# VILLAGE OF ELM GROVE

PLAN COMMISSION MEETING  
Monday, March 7, 2016 \* 7:00 PM \* Court Room

Re: 13400 and 13402 Watertown Plank Road  
Re-Development Concept Plan Review

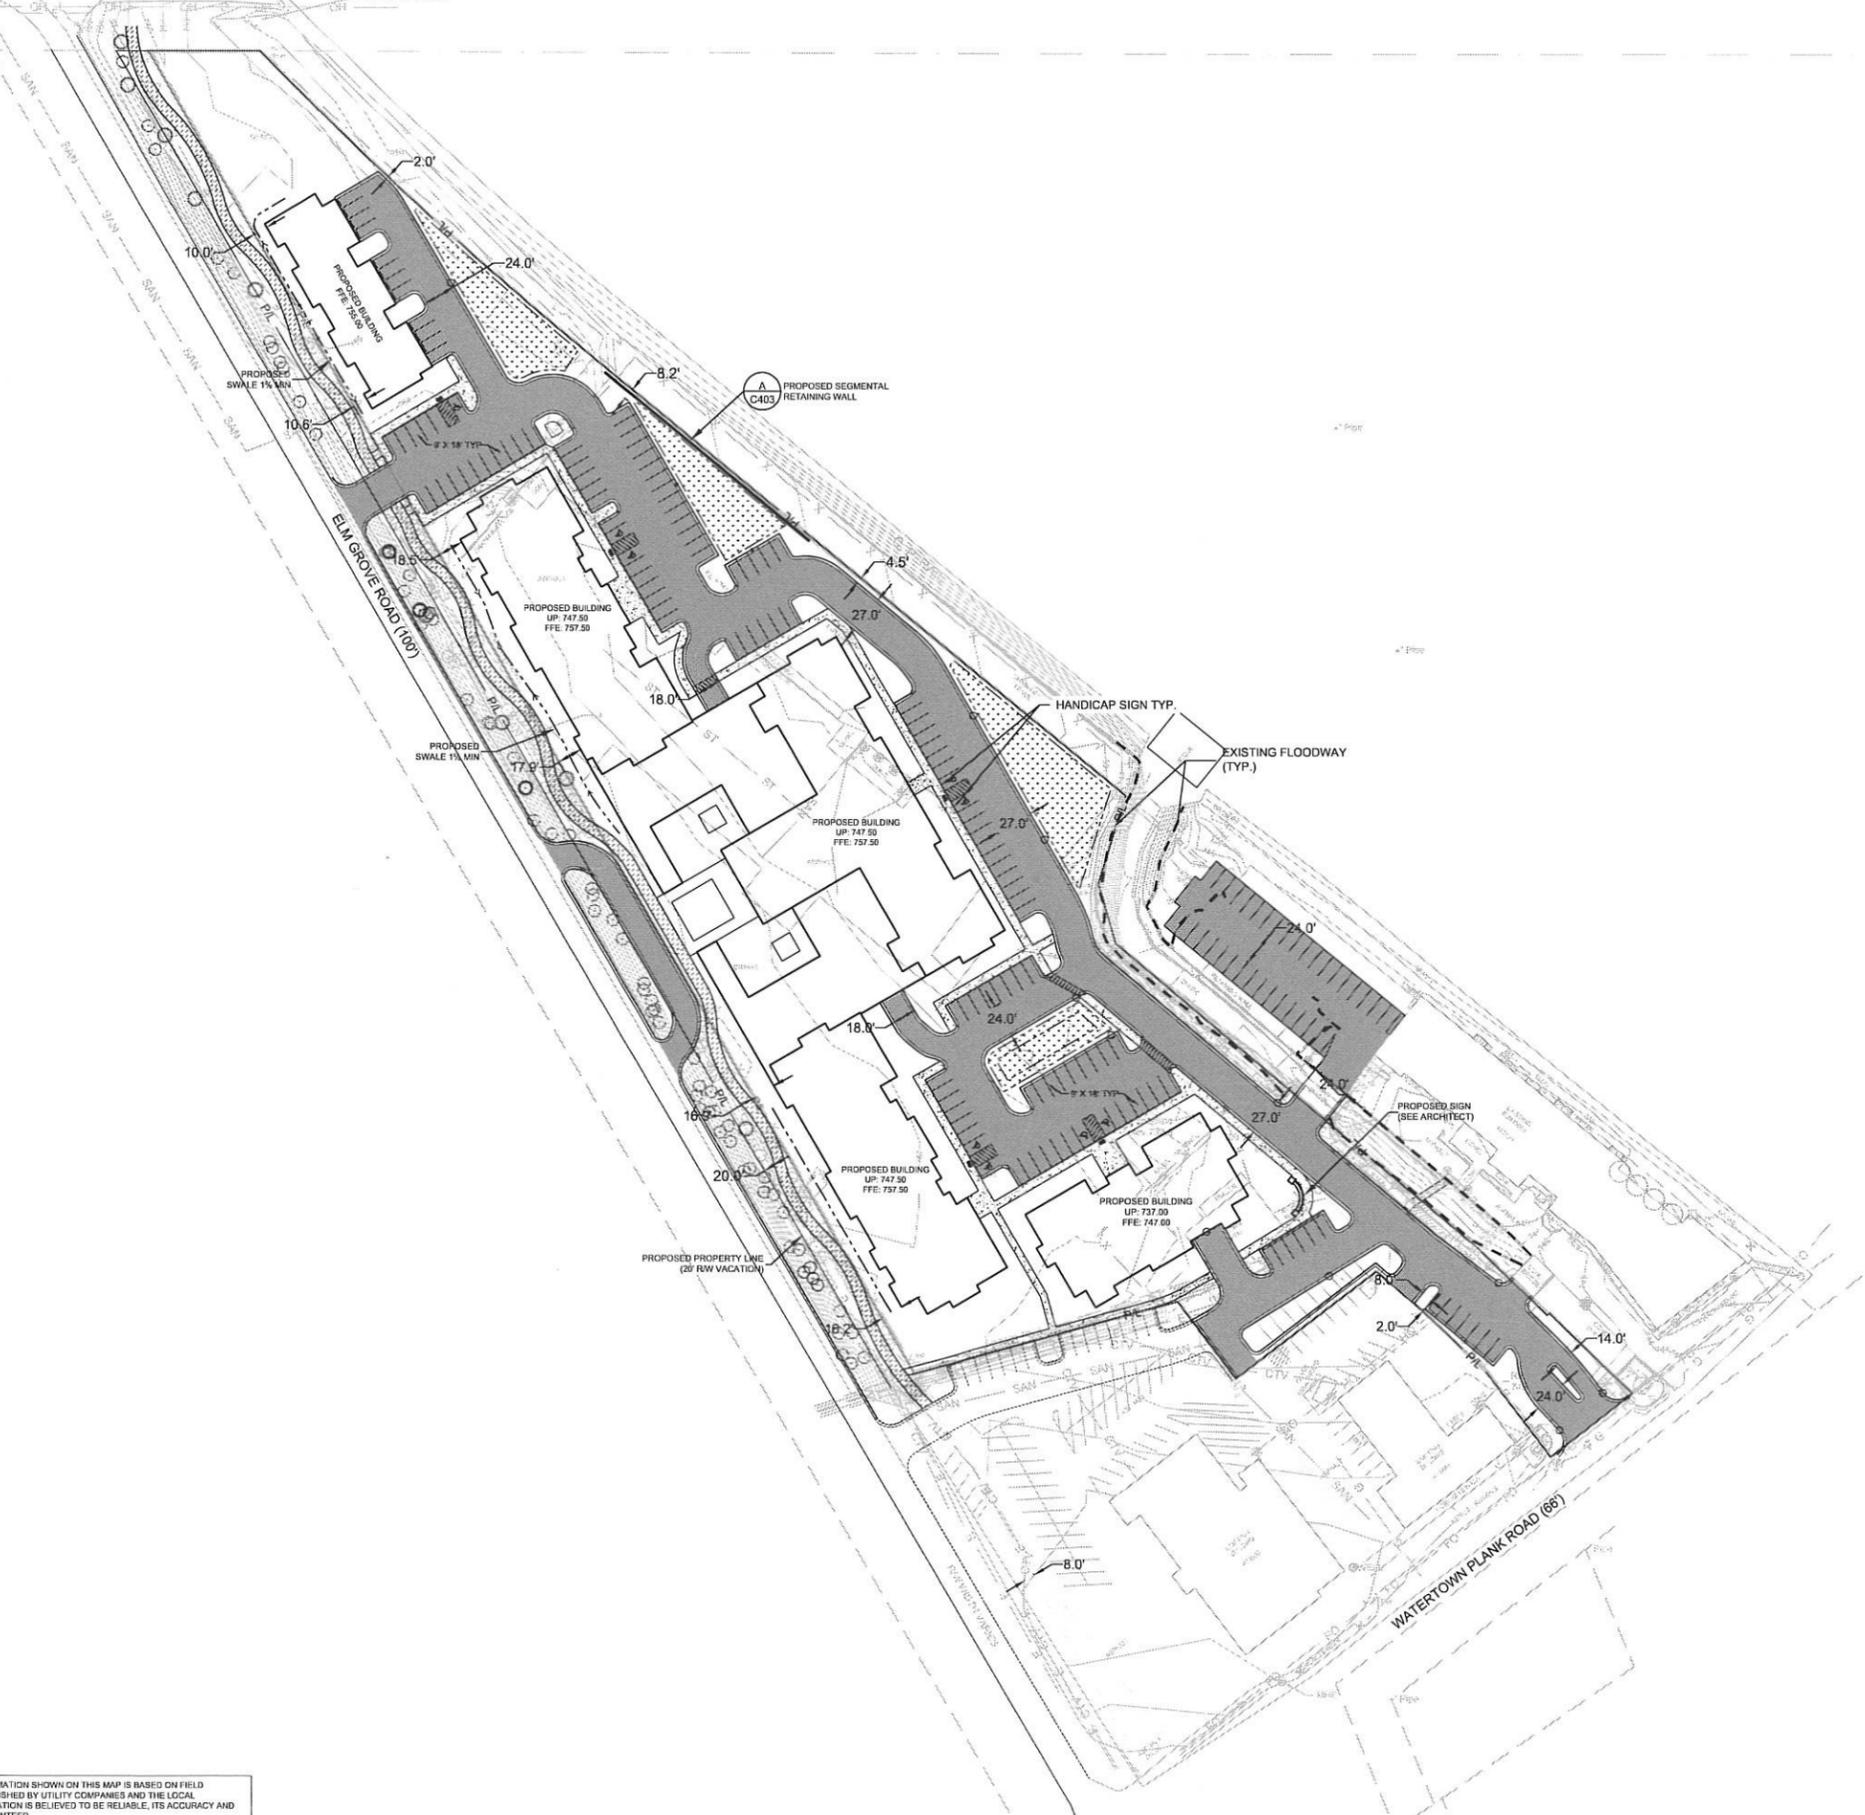
- The Grading Plan shows multiple low points in paved areas adjacent to proposed biofiltration facilities and Underwood Creek without catch basins. Future designs will need to show how these low points will drain into the biofiltration facilities.

- Future designs will need to show an overland flow path from the biofiltration facilities for runoff from large storm events without discharging flows onto neighboring properties.

- Future designs will need to show how drainage will be handled for the circular driveway and the curb and gutter shown along Elm Grove Road.
  - The vertical alignment and cross slope of the proposed bike path may need to be revised to meet ADA requirements if it will be considered an accessible route.

**UTILITY PLAN**

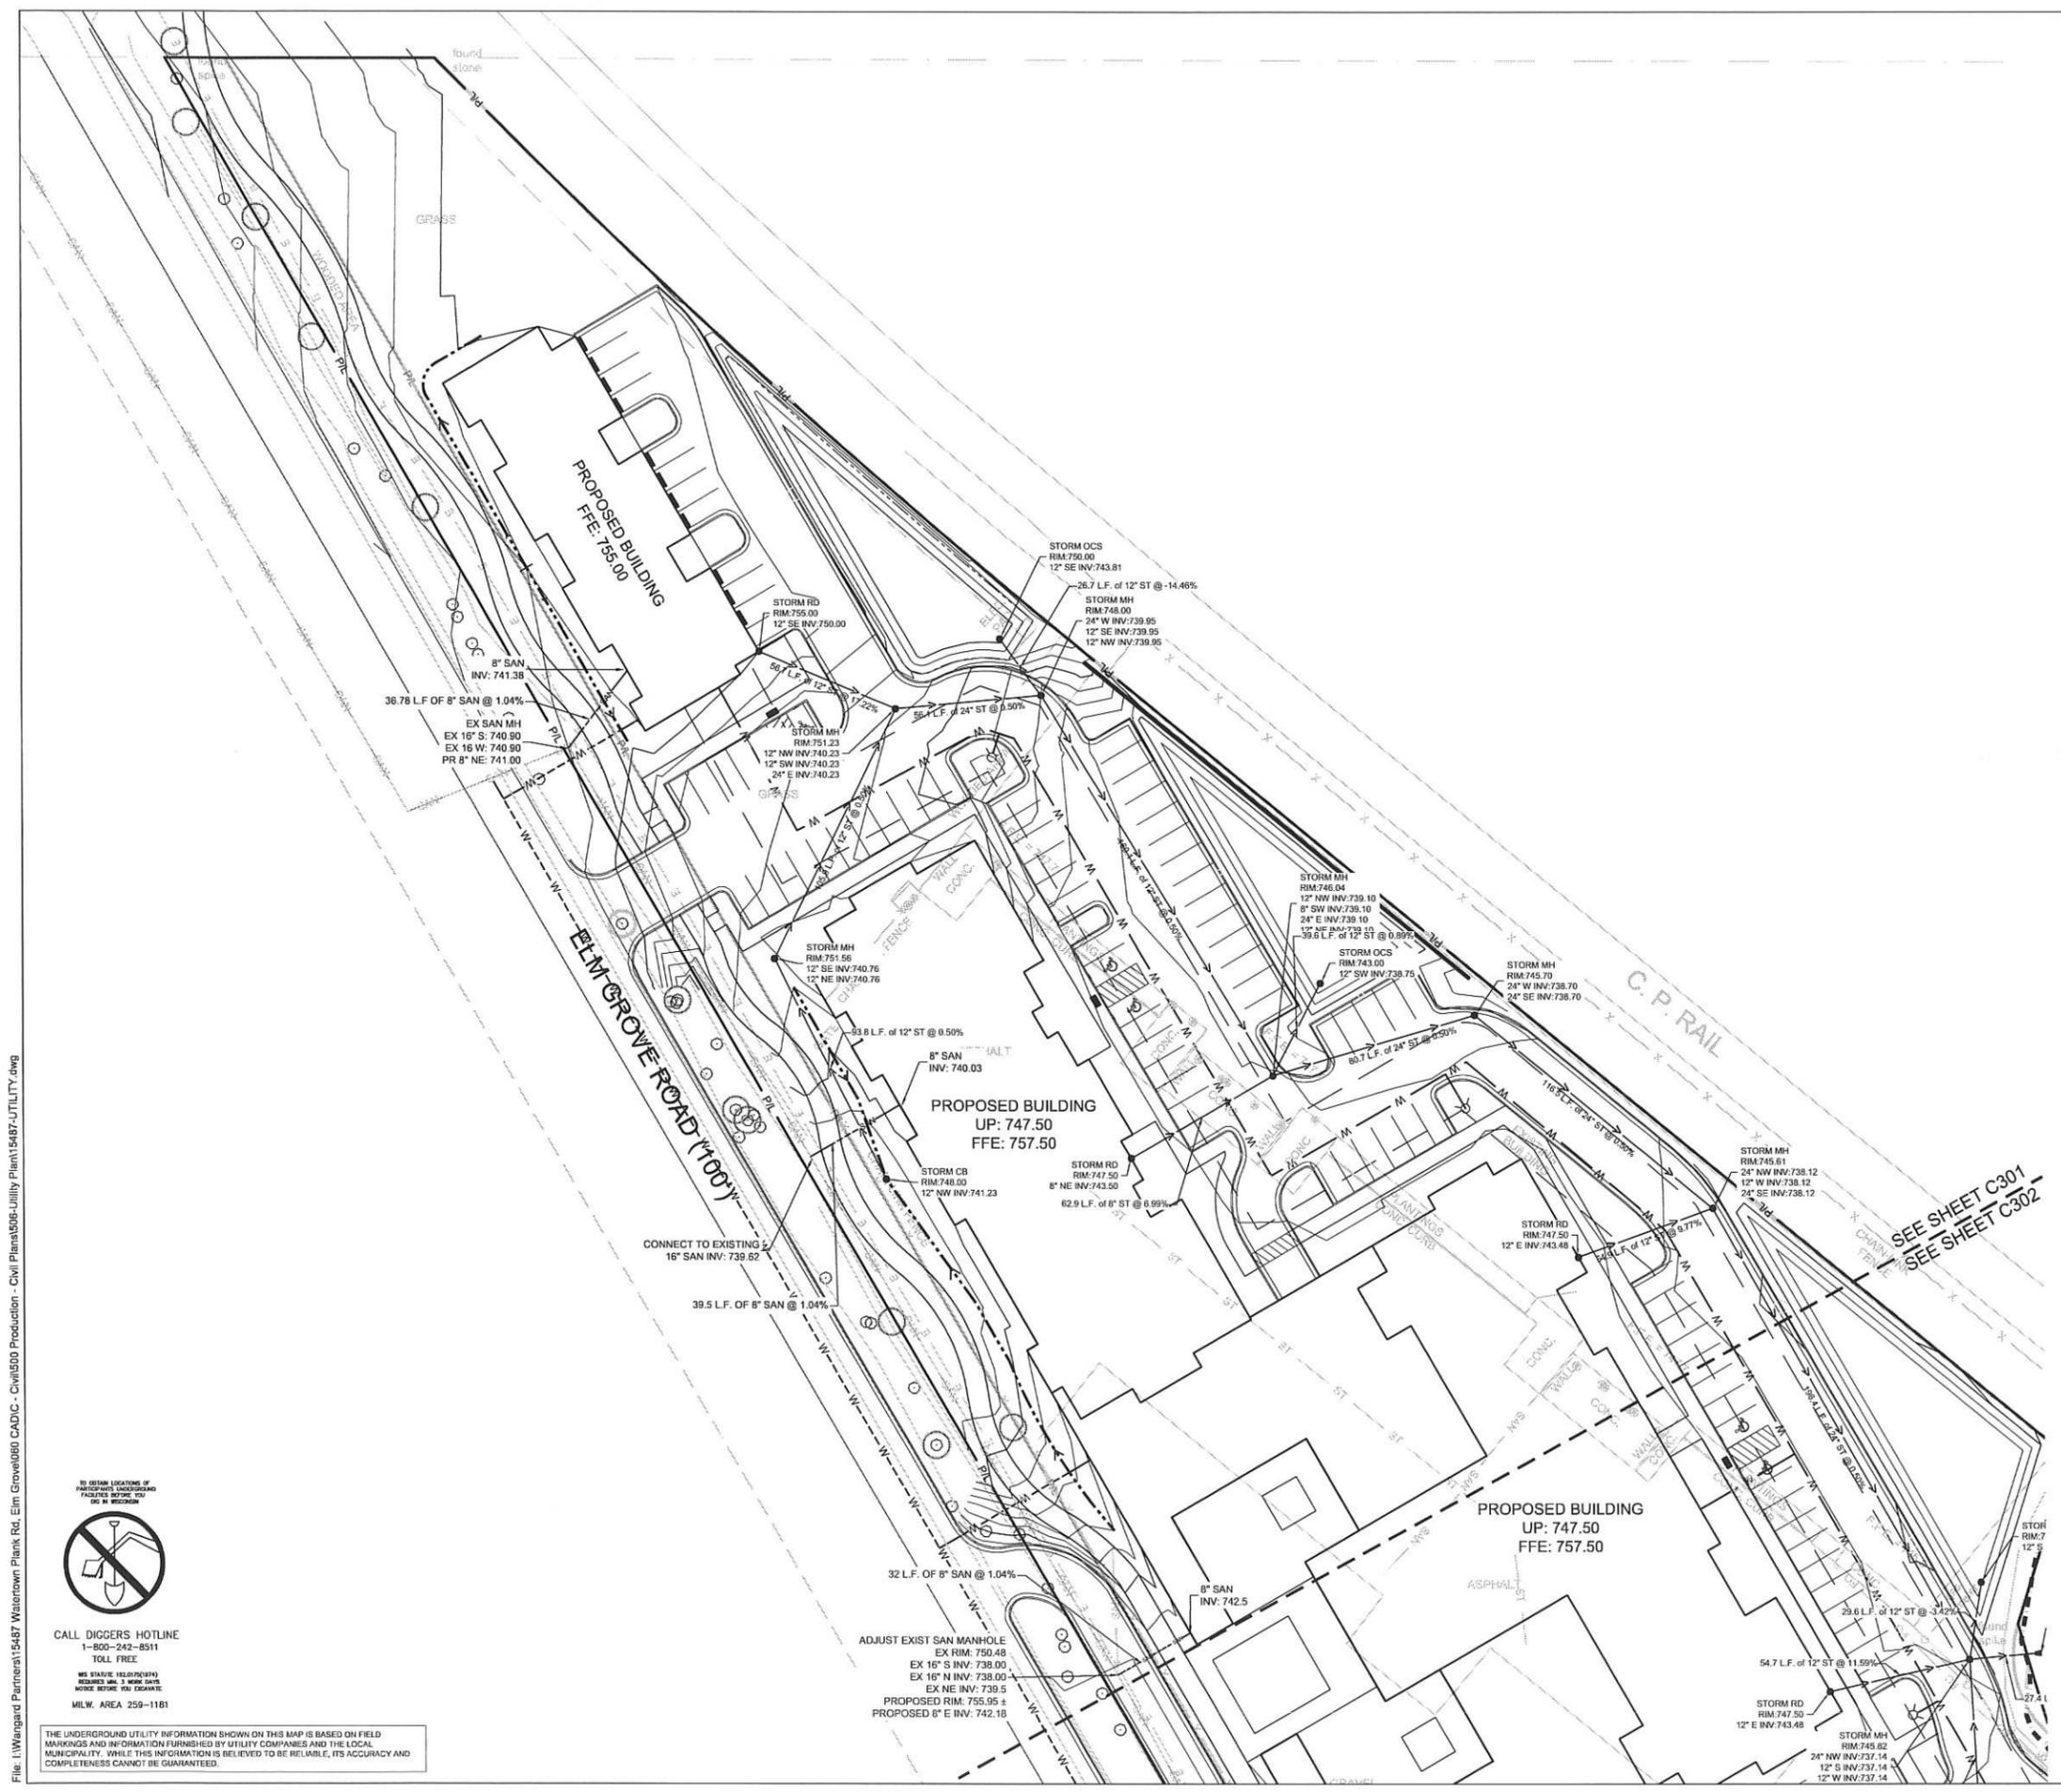
27. The site does not currently have access to public water service. Public water main will need to be extended from the intersection of Elm Grove Road and Wall Street. Before our meeting on February 5<sup>th</sup> the Village had contemplated extending the 16-inch diameter public water main northerly along Elm Grove Road from Wall Street to Watertown Plank Road, then easterly along Watertown Plank Road across the bridge to Legion Drive. Public water service to this site was planned to be provided by a connection to the future water main along Watertown Plank Road.

28. During the meeting on February 5<sup>th</sup> we discussed an alternative plan to possibly extend public water main northerly along Elm Grove Road from Wall Street crossing Watertown Plank Road and continuing on to the northern part of the site. The water main north of Watertown Plank Road has not been sized but would be smaller than 16-inch diameter. Water service to the site would then be provided to the site initially from the water main in Elm Grove Road. This alternative plan may avoid having a public water main in an easement though the site and possibly minimize the exposure of public water main to contamination that exists on the site. The City of Brookfield will need to determine whether on site water main will be considered public or private for either water service piping alternative.

29. Eventually, the 16-inch diameter water main would be extended easterly along Watertown Plank Road from the intersection of Elm Grove Road. If multiple interconnecting connections to the public water system are made, then backflow preventers will need to be installed at each connection point.
